Notice of Meeting
Polk City | Planning and Zoning Commission (P&Z)

REZONING REVIEW

Project: Holly Woods

Project: Antler Ridge Preliminary Plat

PROJECT NO.: 21255
DATE: 08/24/22
DRAWN BY: TJH
CHECKED BY: RJS
SHEET SIZE: 22" X 34"
SHEET TITLE: **RZ-R1**
SHEET NO.: 1/1

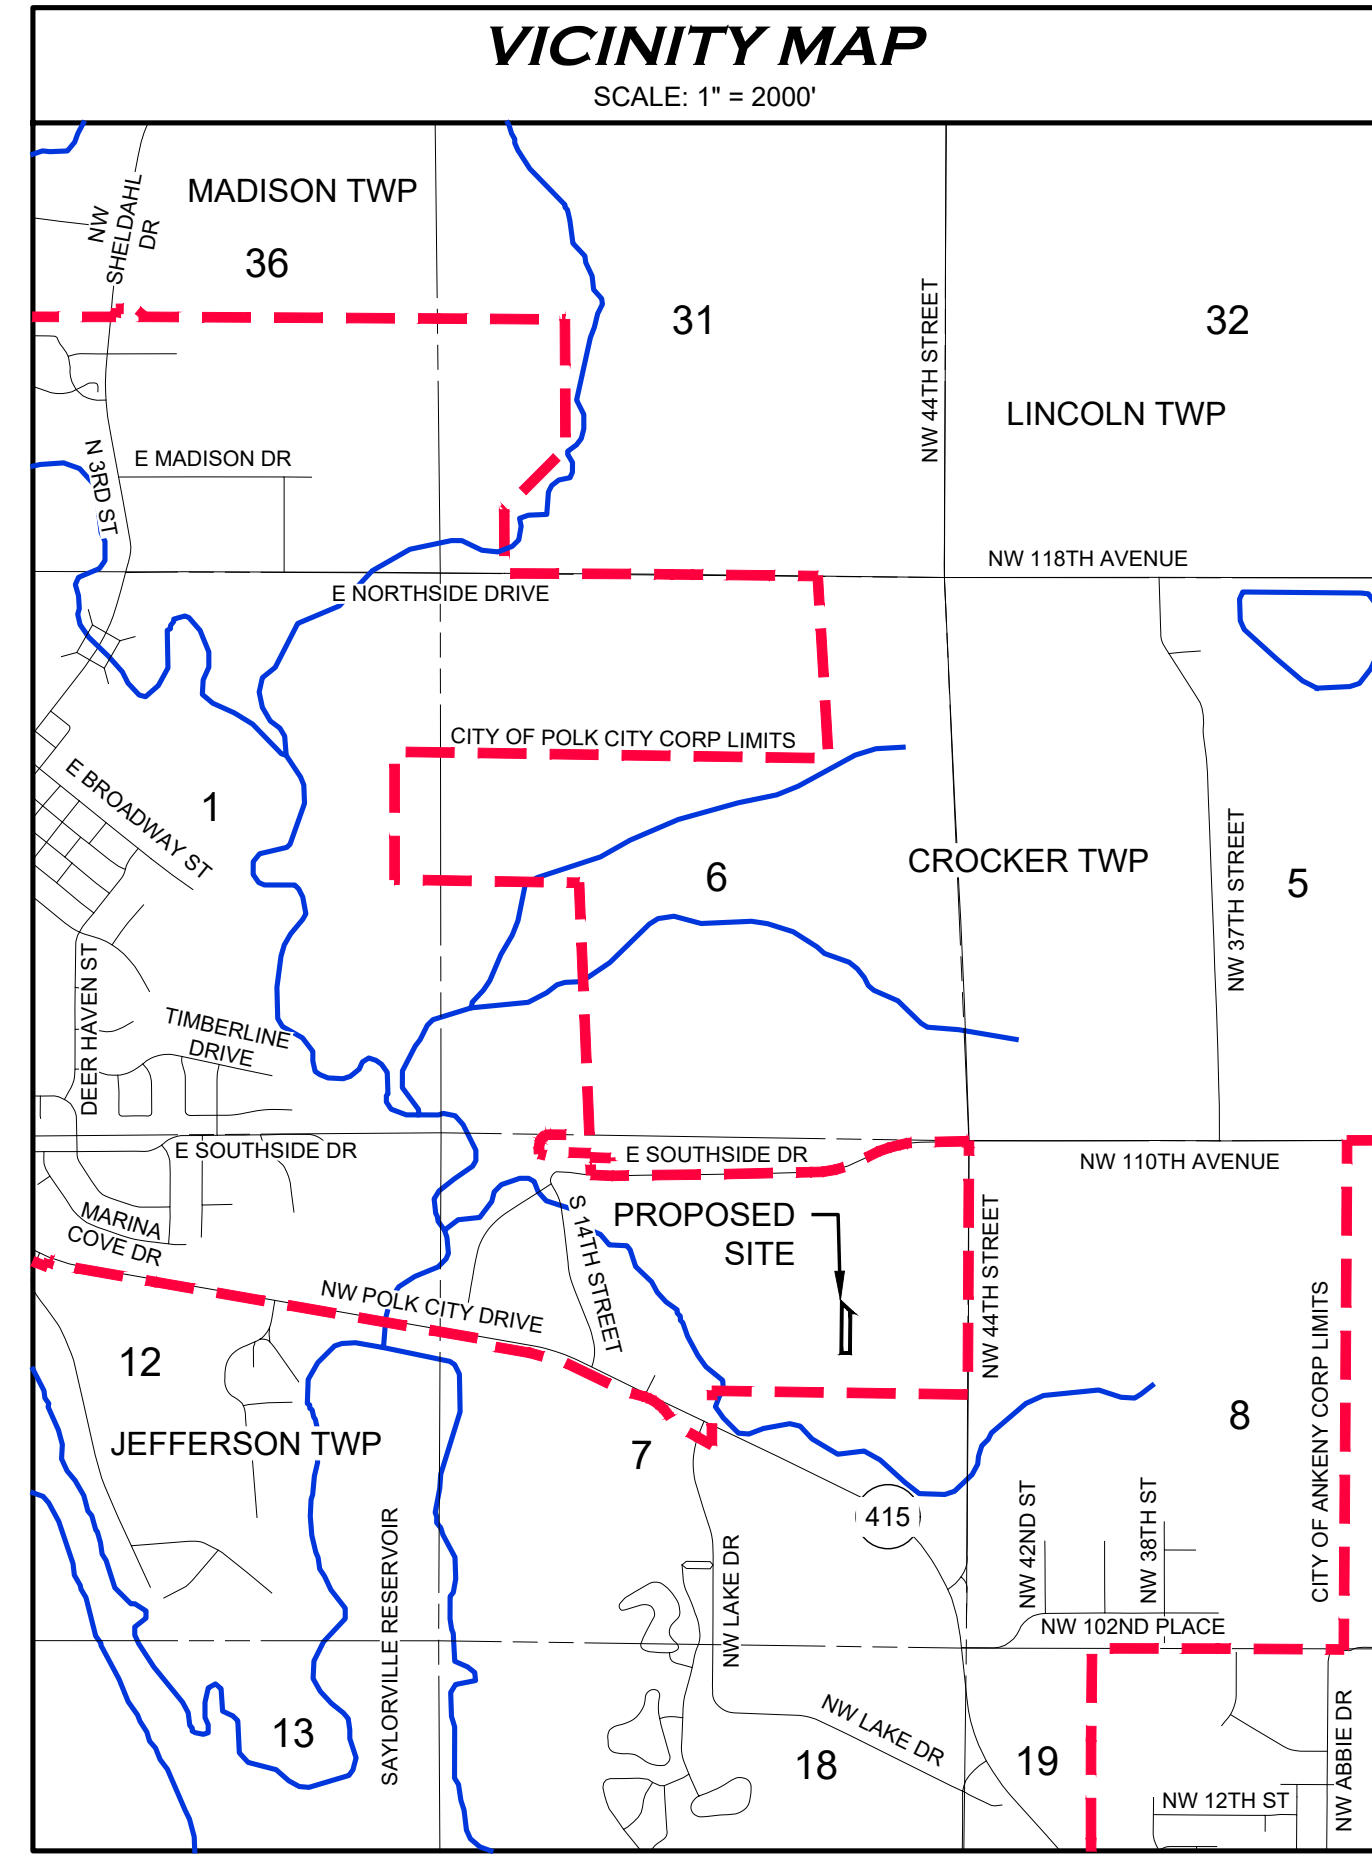
The Petition to Rezone is in accordance with the city's approval of the Preliminary Plat. The entire buffer area surrounding this rezoning is owned by Antler Ridge LLC or Genevieve Lillskau; both parties have consented to the proposed rezoning.

PHASING PLAN

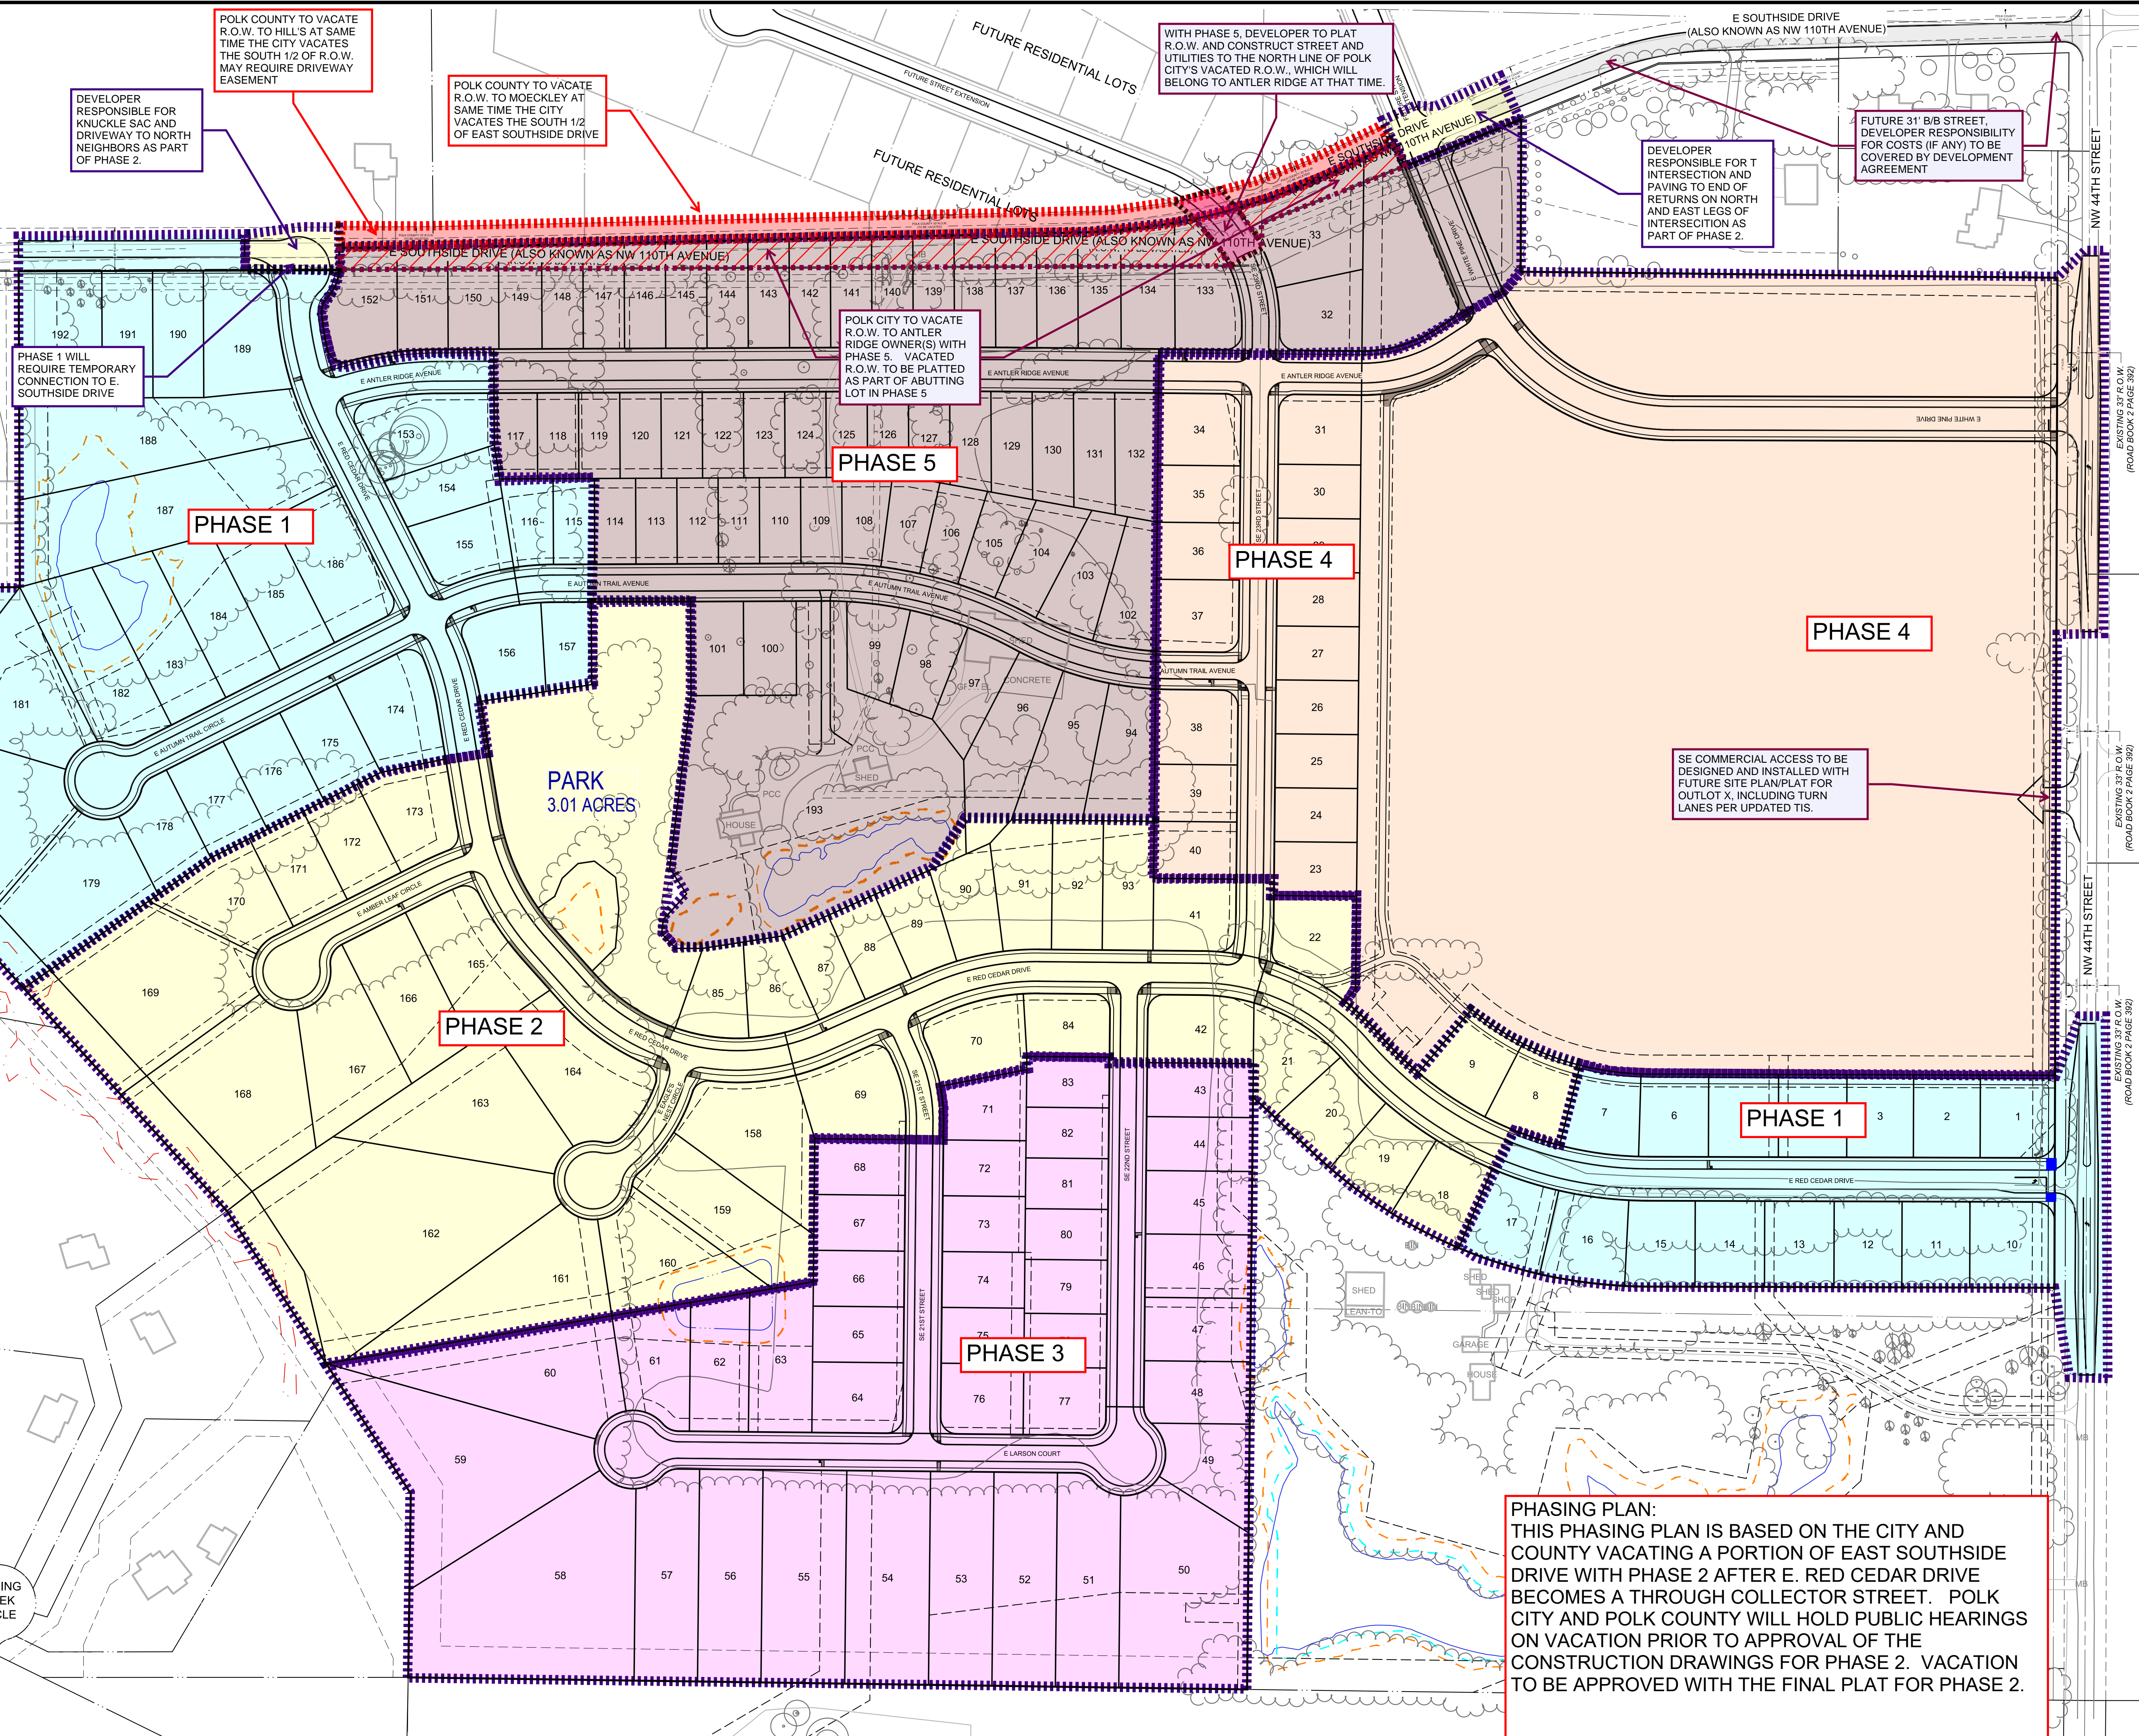
1. **Park & Recreational Trail.** The developer plans to dedicate a 3.06-acre park located west of the existing home on Lot 195. A minimum of 75% of this park area will be graded to 5% max., with the exception of an existing stand of trees that will remain. A Recreational Trail will be paved along the south side of Red Cedar Drive, from the park to SE 23rd Street. From SE 23rd Street, the trail will extend along the rear of Lots 1-9 east to NE 44th Street and along the rear of Lot Z north to E. Southside Drive. A trail will be constructed along the east side of Outlot Z to match the trail in Holly Woods.

2. **Zoning.** The current zoning on the property does not match the proposed lot layout. The developer will need to request a cleanup rezoning prior to final platting that revises the zoning district boundaries to match proposed lot lines and street centerlines to avoid confusion in the enforcement of zoning regulations.

4. **E. Southside Drive.** City staff agrees with the concept to realign E. Southside Drive in order to avoid reconstruction of a large portion of this street, similar to the realignment of E. Southside Drive in the Marina Cove subdivision.

- a. The north half of E. Southside Drive is owned by Polk County. City staff and the developer have had preliminary discussions with the county and they appear to be in agreement with the developer's plan to vacate a portion of this street. However, Polk County will need to provide written approval of this street vacation prior to Council approval of the construction drawings for any streets, storm sewers, or water main in this subdivision.

- b. Vacation of portions of this right-of-way will require Public Hearings by both Polk City and Polk County. A revised Phasing Plan will need to be provided that addresses the sequence of construction and vacation in order to maintain traffic through all phases of development.

- c. A Development Agreement may be required to define the city's and the developer's responsibility for resurfacing and/or reconstruction of E. Southside Drive. This Agreement will need to be approved prior to approval of the Construction Drawings for Antler Ridge Plat 1.

5. **Sanitary Sewer.** This Preliminary Plat includes relocation of the SE Trunk Sewer from its planned location along the creek to an overdepth sewer through Antler Ridge. A Development Agreement is required to define the city's responsibility for cost sharing associated with upsizing the sanitary trunk sewer and for overdepth construction, based on information provided by the developer and the SE Trunk Sewer Study. This Agreement will need to be approved by prior to approval of the Construction Drawings for Antler Ridge Plat 1 or Holly Woods Plat 1.

NAI NO.: 21255
SHEET NO.: 1/16
SHEET TITLE: PP-1
SHEET SIZE: 24" X 36"

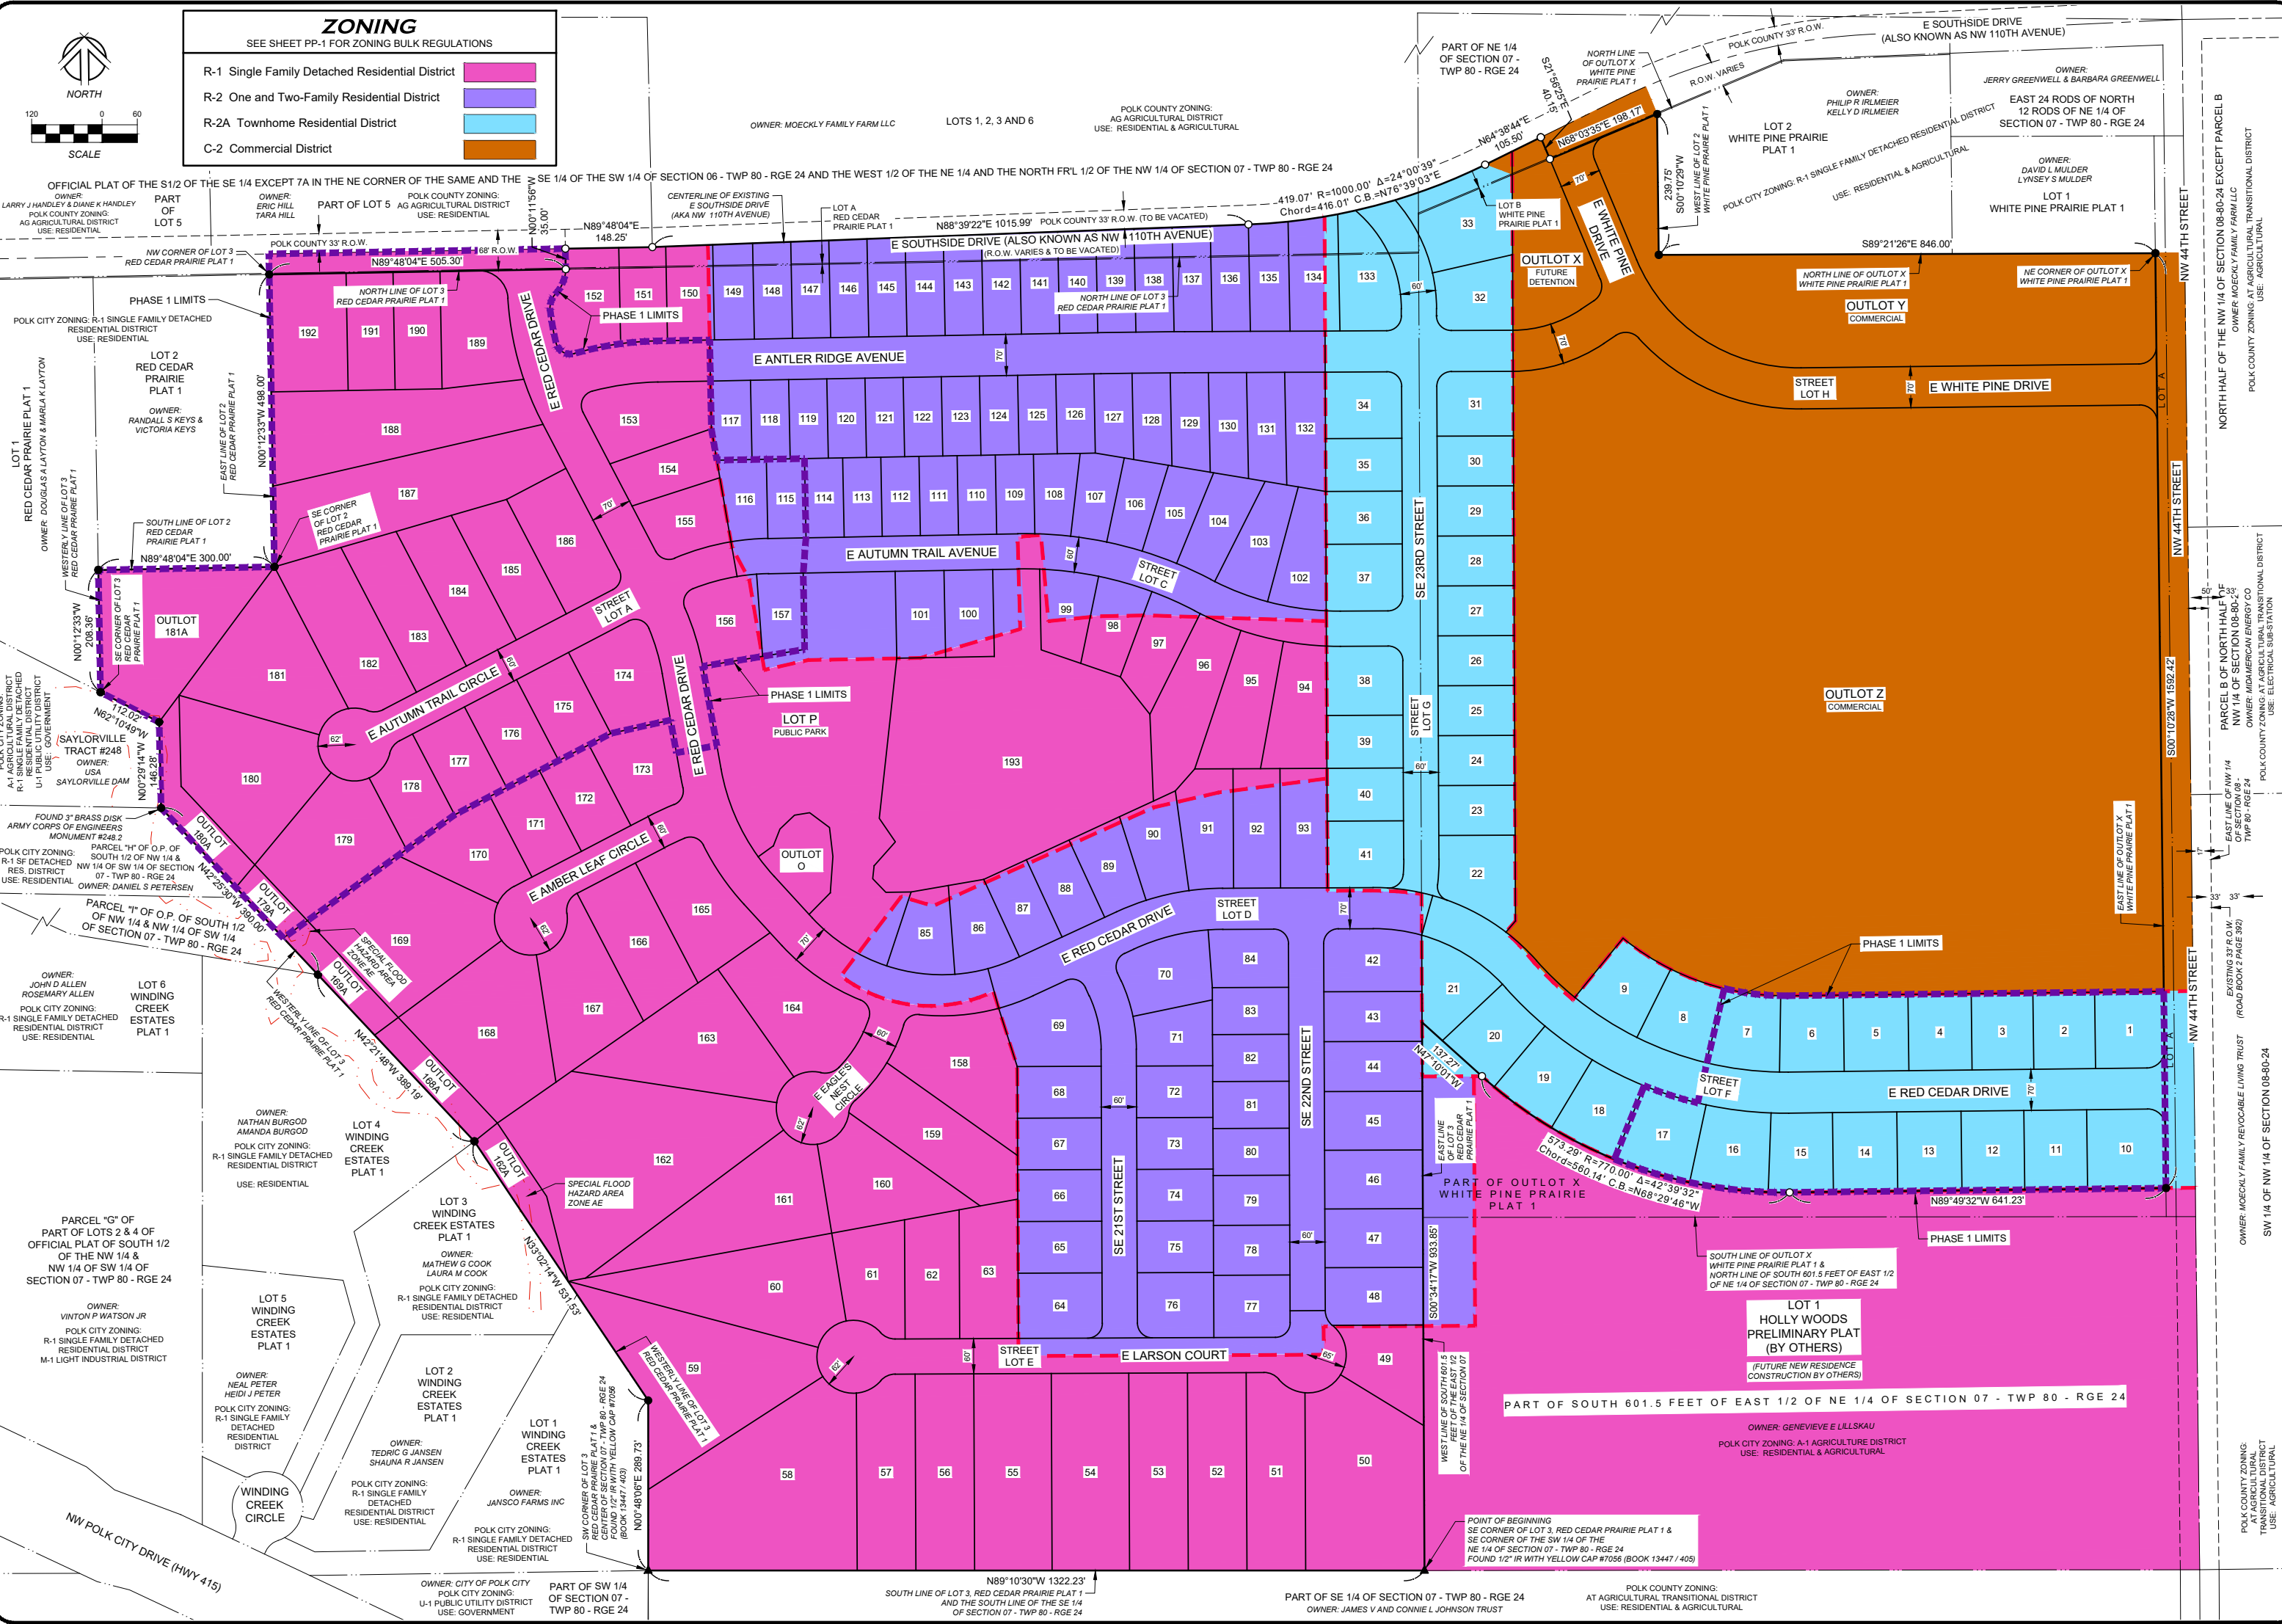
1. Show and label the off-site Storm Sewer Easement for the Outlot X detention outlet. Add a note stating "the developer shall obtain the property owner's approval of the Storm Sewer Easement on Moeckly Farms LLC property, on a form that has been approved by the City Attorney, prior to approval of the construction drawings for said public improvement and prior to Polk County's vacation of any portion of the right-of-way for NW 110th Avenue (E. Southside Drive)."
2. Show and label the sanitary sewer easements across Outlot Y for the sanitary sewers to White Pine Prairie Plat 1.
3. Show and label the S.T.M.F.E. on Outlot X.
